Re: BZA Application No. 17309 – Chain Bridge Road, N.W.

Analysis Of Tree Preservation At The Chain Bridge Road Project

Subject: BZA Case #17309 Application of Dorchester Associates, Inc.
Chain Bridge Road Traffic Study Evaluation

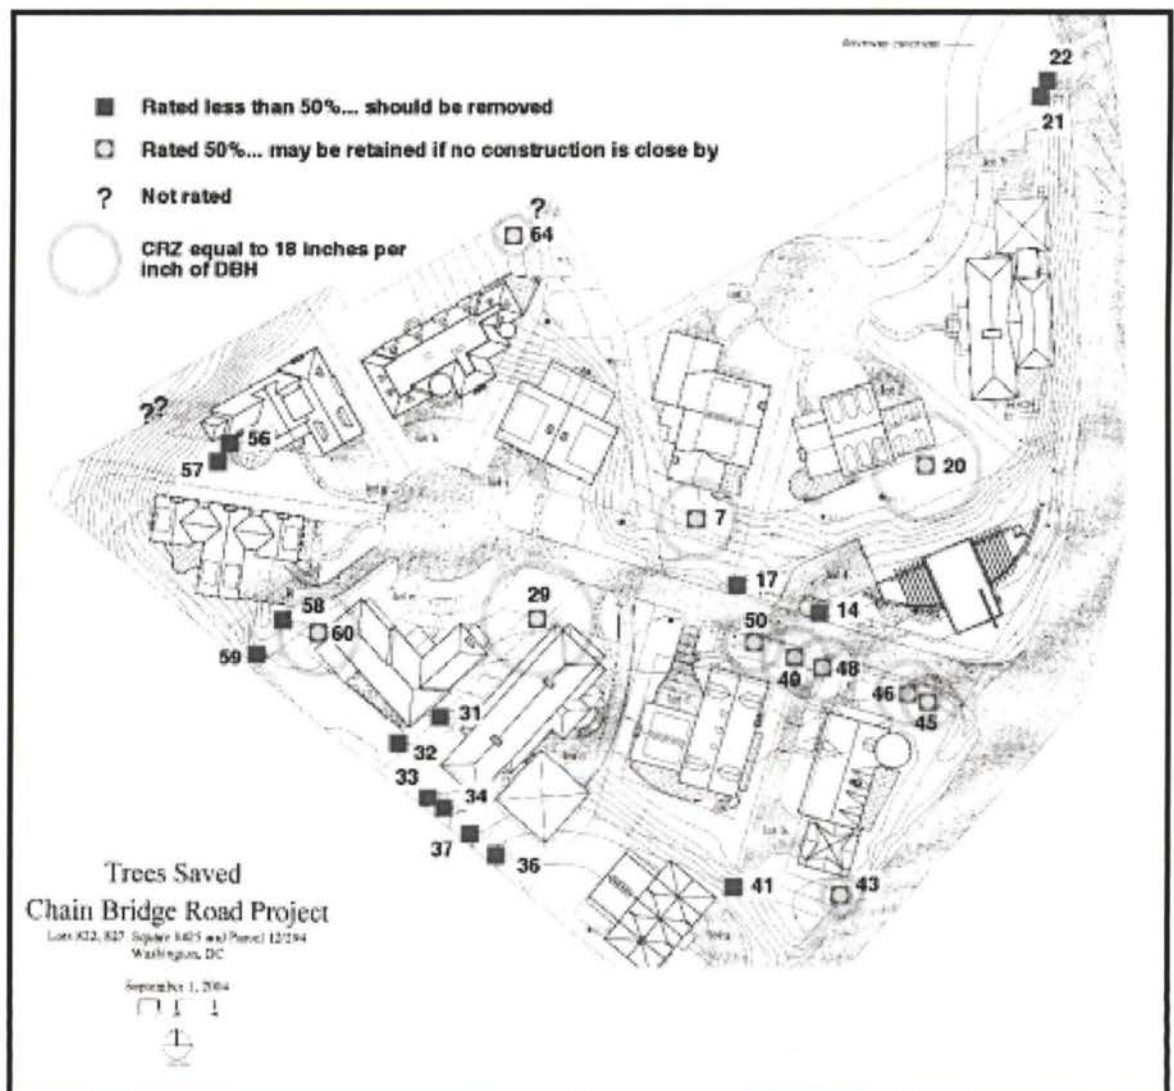
Having worked on hundreds of construction projects as a professional arborist, I can say that as far as tree preservation is concerned, it is essential that people be realistic about the prospects for each individual tree. Failure to be realistic will result in dying trees left standing near new houses.

The plan for Chain Bridge Road Project as presented simply states that the trees will be saved; there is no tree preservation plan providing details as to how this actually will be accomplished; there is no grading plan to see what ground will be left undisturbed. It is left to a reviewer to accept the tree save premise as a leap of faith.

realistic and objective arborist would look at these plans, and realize that only a few of the larger trees have any chance at all of remaining in a viable state when this project is complete.

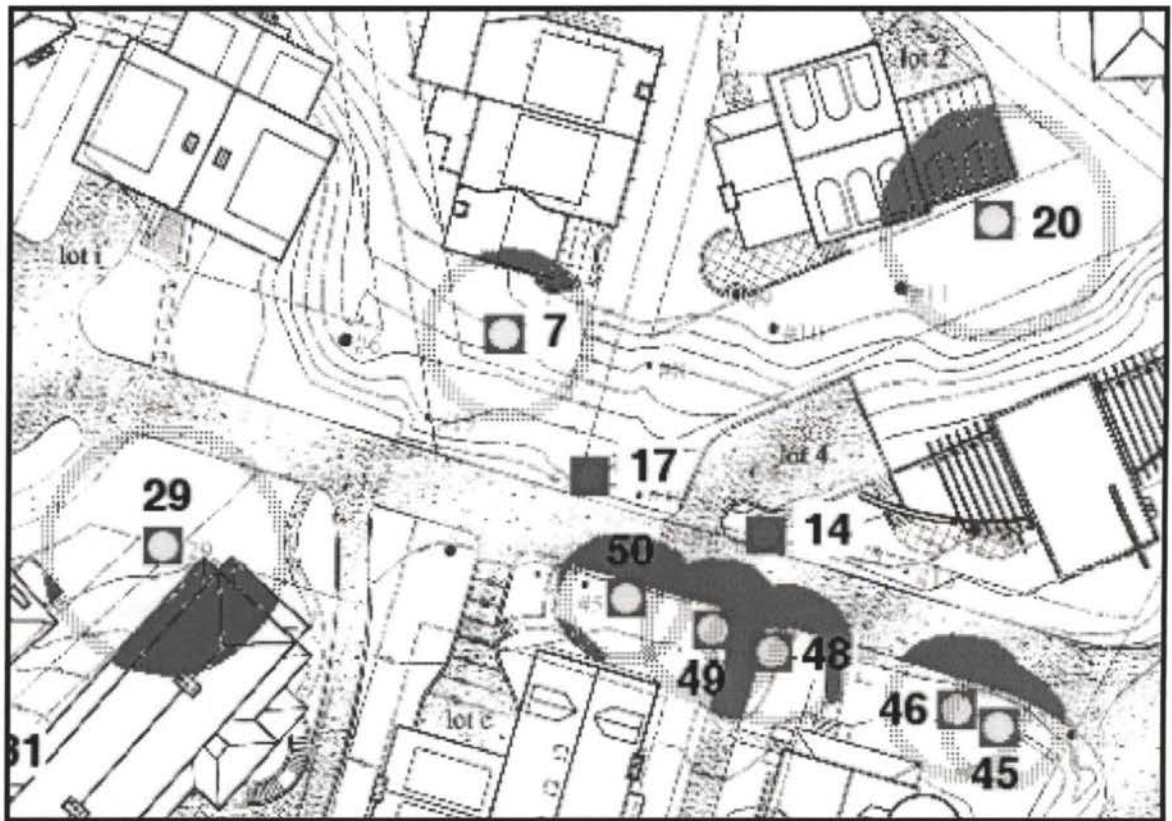
First, let's look at the *Trees Saved* plan focusing on the trees Mr. Bloch rated fifty percent or less; these are trees he stated in his July 20, 2002 letter to Mr. Bender either should be removed now (rated less than 50%), or would not tolerate construction nearby (rated 50%). The *Trees Saved* plan purports to preserve these nonviable trees.

It also is readily apparent that most of the vulnerable, construction-intolerant trees — those Mr. Bloch rated at 50% — are very close to construction. While these trees are shown on the plans as saved, it is obvious that they cannot be saved.

Next, let's look at a closer detail of this part of the plan. The detail below shows the entrance road. It shows only the trees rated fifty percent or less... those that Mr. Bender's arborist says should be removed now or will not tolerate construction nearby. It does not show trees that Mr. Bloch says should remain viable. The plan claims that all the trees shown here will be preserved. The solid rust colored areas are the portions of the CRZ of each tree that will be graded out if the builder manages to dig only the exact footprint of each structure. This is not possible, of course; there is always some over-dig to enable construction of foundations. In fact, only an extremely naïve person would think these huge houses

can be built without substantial grading and disruption of the trees' root zones. Certainly it will be impossible to put tree protection fencing at the drip lines of trees that stand next to houses, as the plan claims will be done. In addition, their canopies⁵ will have to be pruned substantially to fit these large houses in. This will dramatically alter the appearance of some of these trees. In the case of the beech trees, radical pruning could be destructive where large branches must be cut off.

The entrance roadway has to be widened significantly to achieve the sixteen-foot width being proposed. The plan does not show where utilities will be located, but along the entrance road is the logical place for water, sewer, and electric.

Given that the beeches are old and that this species is considered one of the most intolerant species there is, their immediate demise is inevitable if this project is carried out as planned.

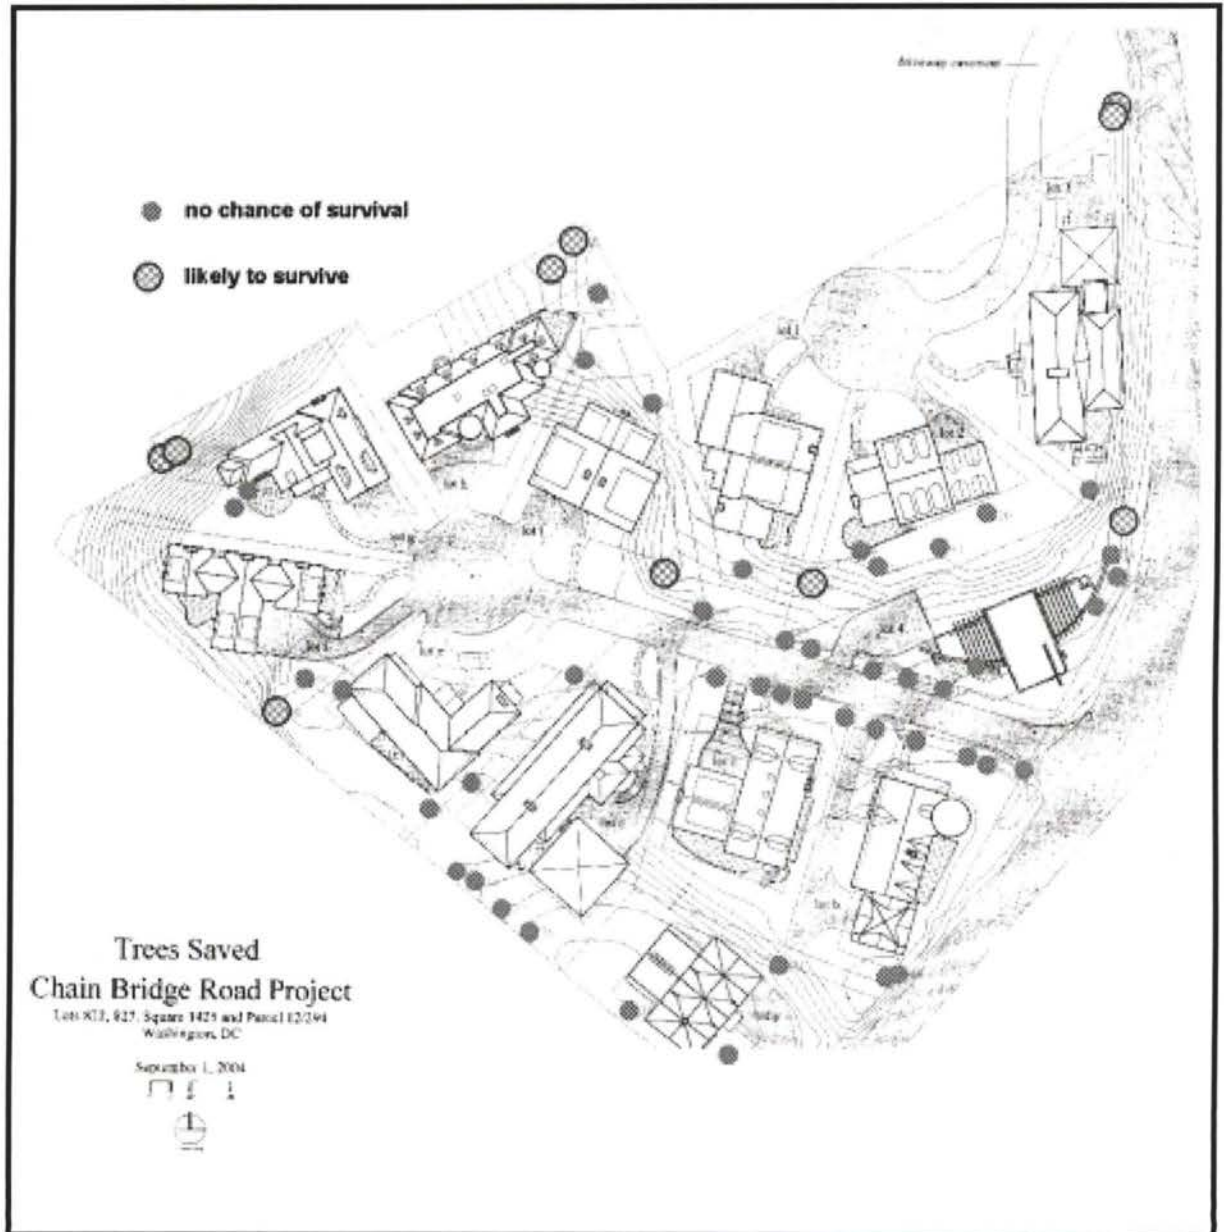
Let's take a close look at one of these highly rated trees: tree #9, a white oak (*Quercus alba*) over twenty-four inches DBH, rated seventy percent by Mr. Bloch. This detail illustrates how overly optimistic the plans for Chain Bridge Road Project are. This tree has a patio built around at least fifty percent of its base. At least one-quarter of its CRZ is lost to building and patio.
